9 April 2021

Re: Statement of environmental effects - Section 4.55 (1A) Modification to SSD 7733 - waste recycling and transfer facility at 46-48 Peachtree Road, Penrith

Benedict proposes a modification to development consent SSD 7733 (Mod 1) to change the material forming the external walls of the main shed. The current approved design includes walls with part masonry and part colorbond construction. The proposed modification includes masonry for all of the external walls.

Figure 2.1 Plan excerpt of proposed layout

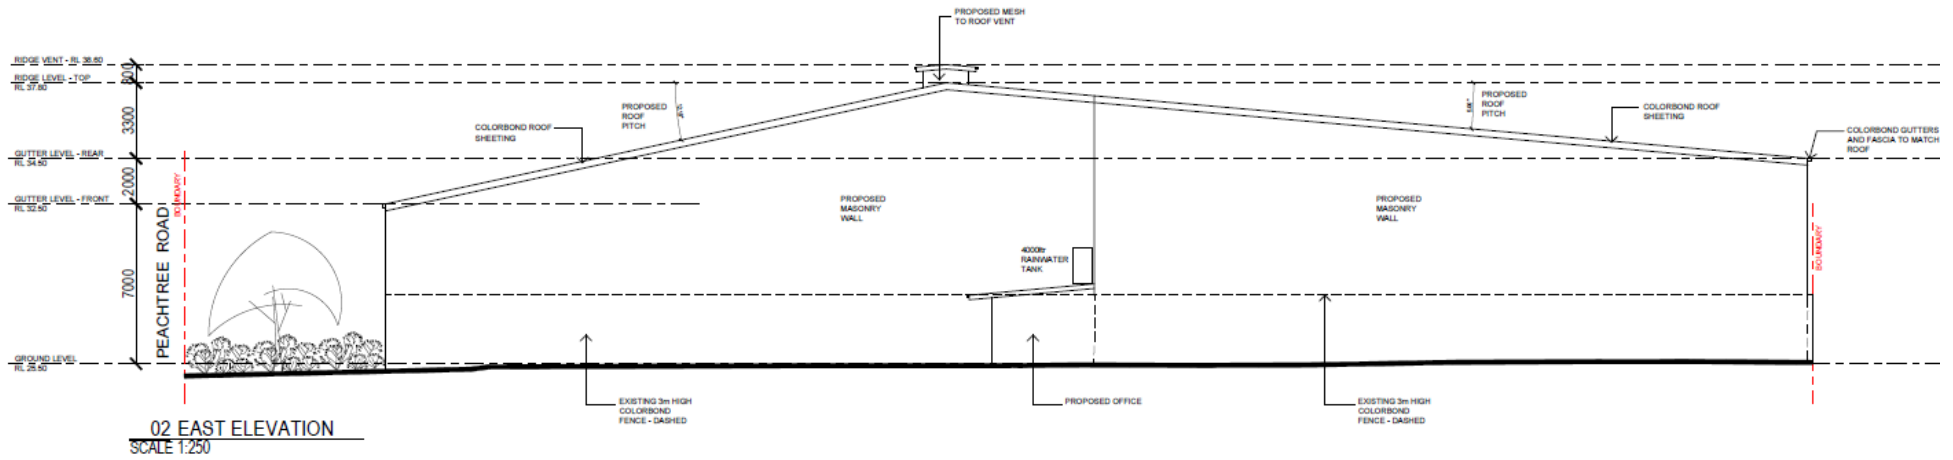
Plan excerpts of the proposed layout and main (east) elevation are provided below in Figure 2.1 and Figure 2.2, respectively. The approved plans are provided in Appendix A and the proposed Plan are provided in Appendix B.

Photograph 3.1 50 Peachtree Road

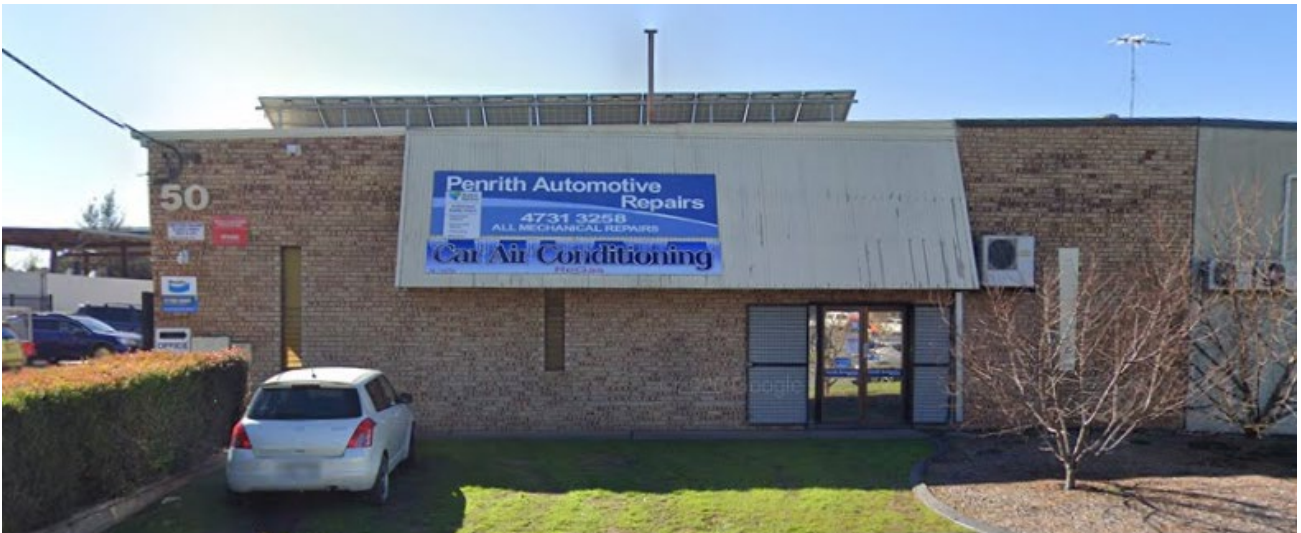
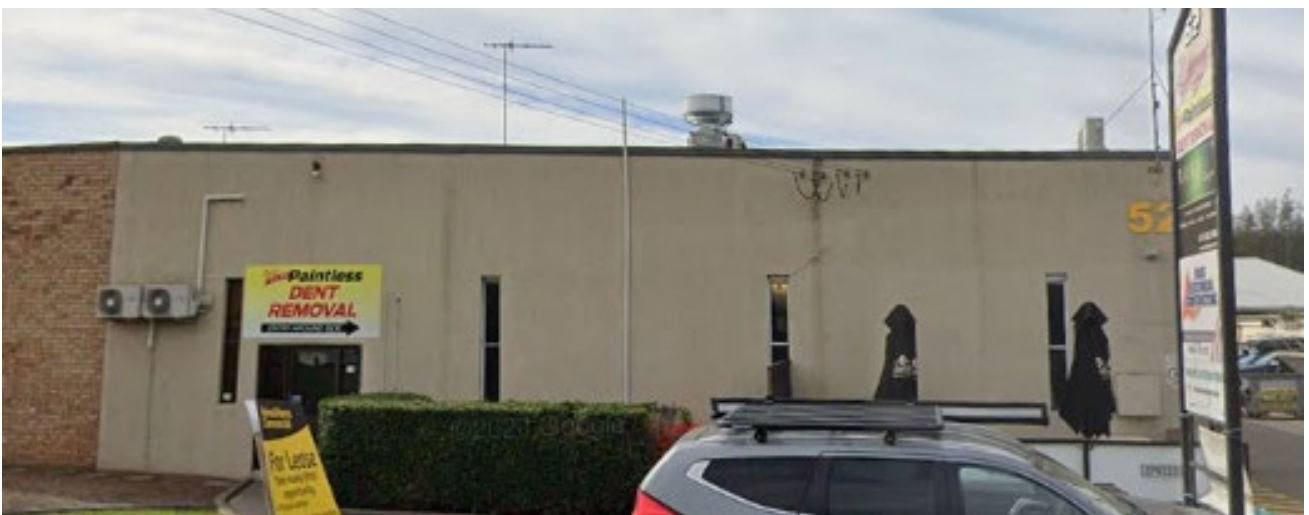
It is not considered that the proposed modification will change these outcomes. The proposed use of masonry on the external walls is considered to be in keeping with the industrial character of the area. Concrete and brickwork is used extensively on buildings in vicinity of the site, including either side of the site, to the east at 50 and 52 Peachtree Road and to the west at 44 Peachtree Road, as shown in Photographs 3.1 to 3.3.

02 EAST ELEVATION
SCALE 1:250

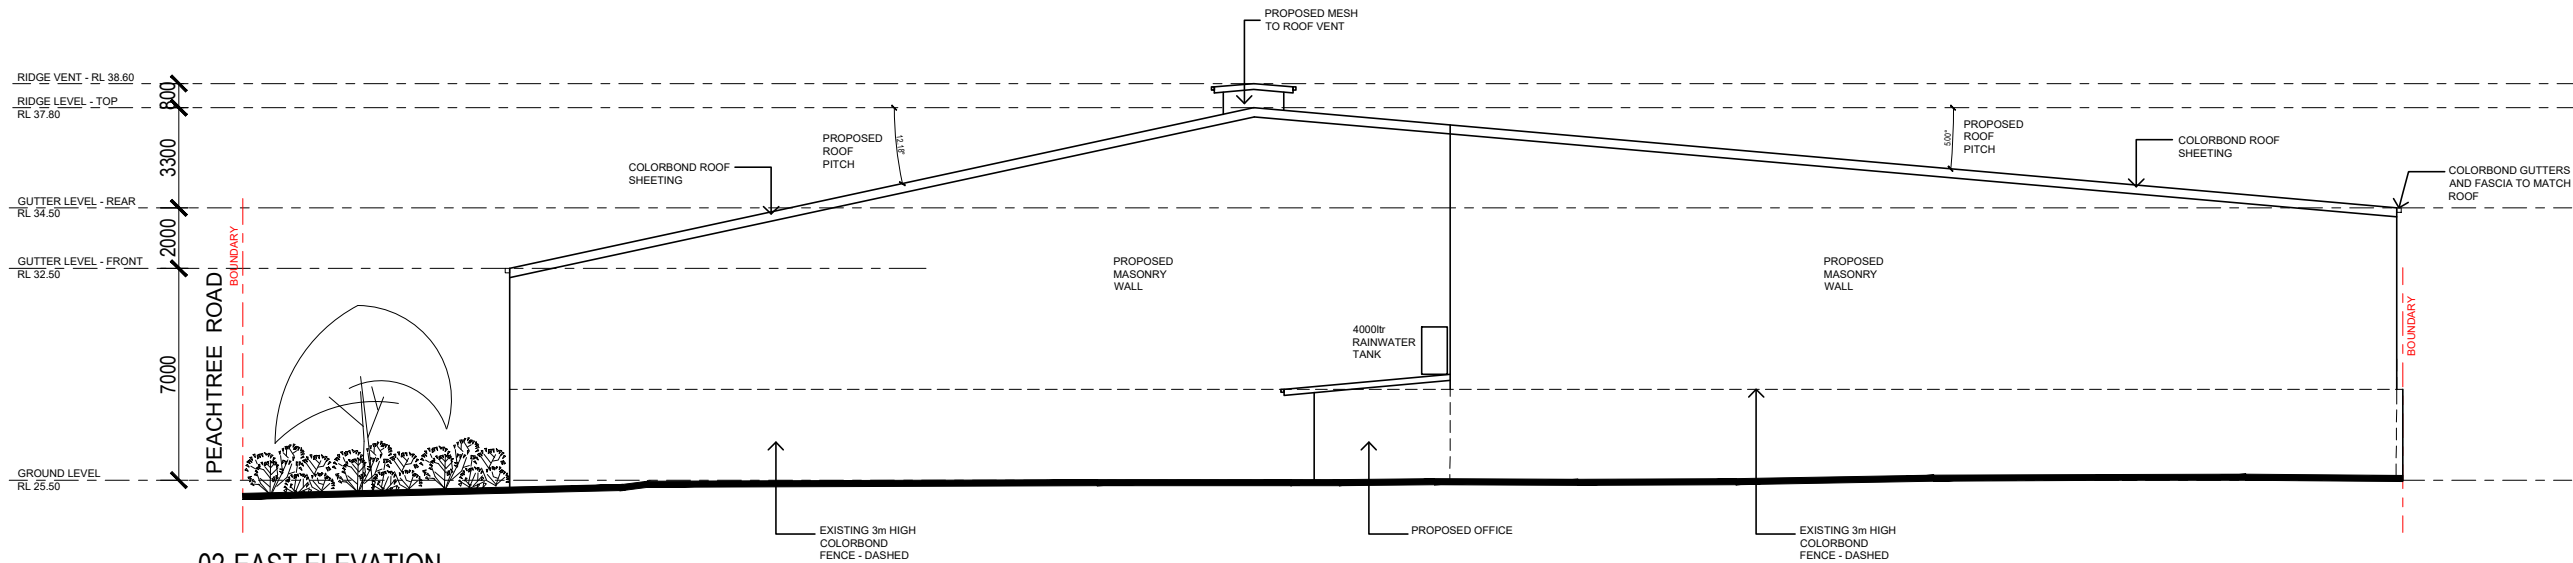
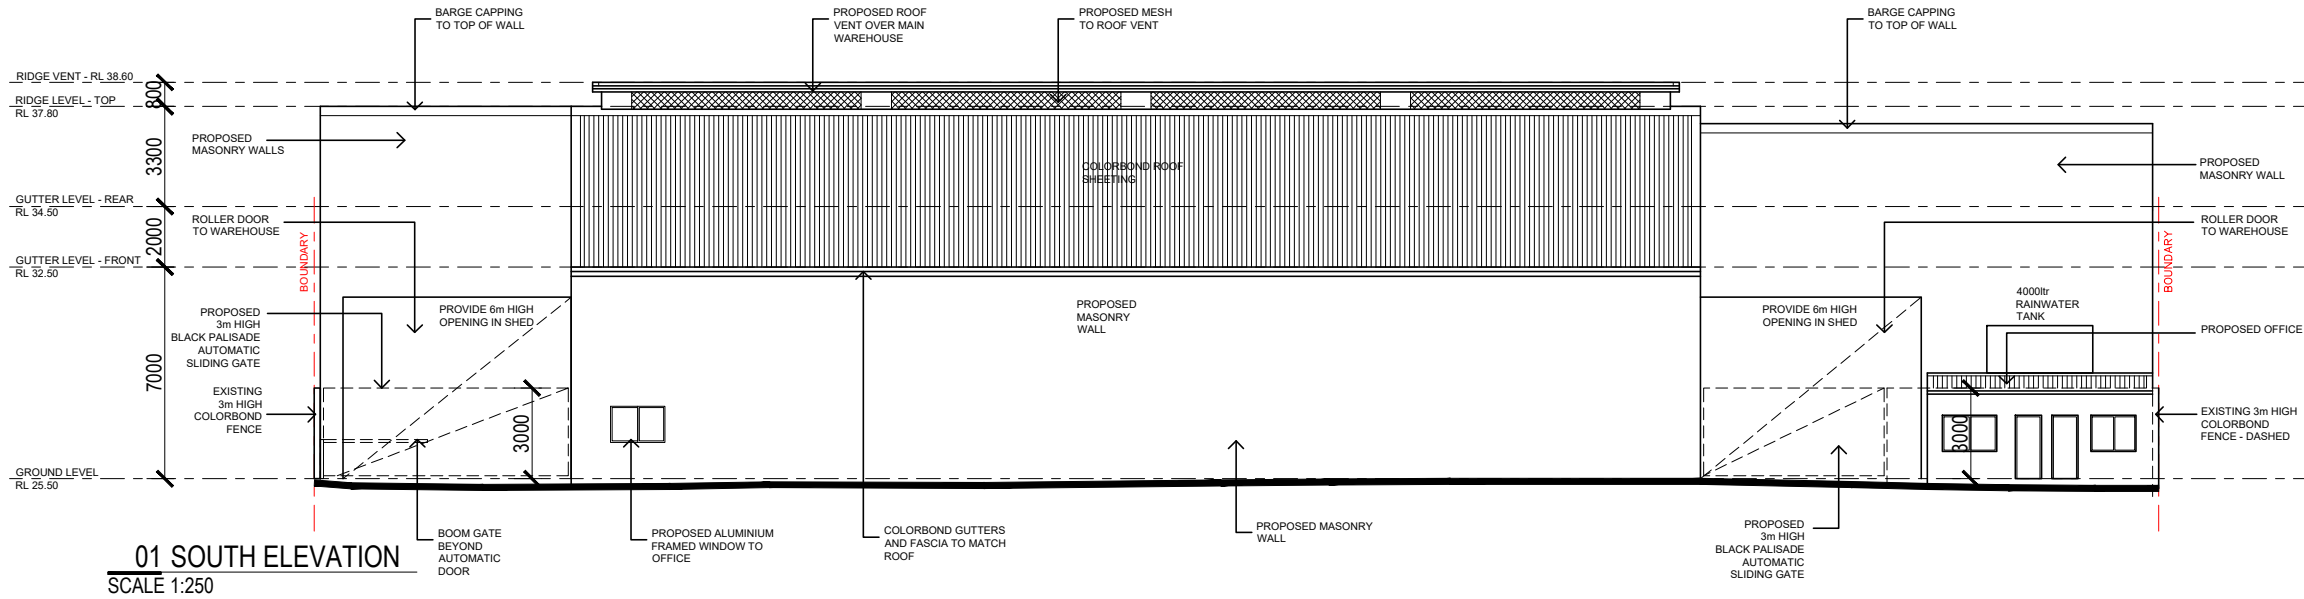
The proposed change of material to masonry is required to increase the fire safety rating of the external walls of the main shed, where it is close to the boundary with adjoining properties.
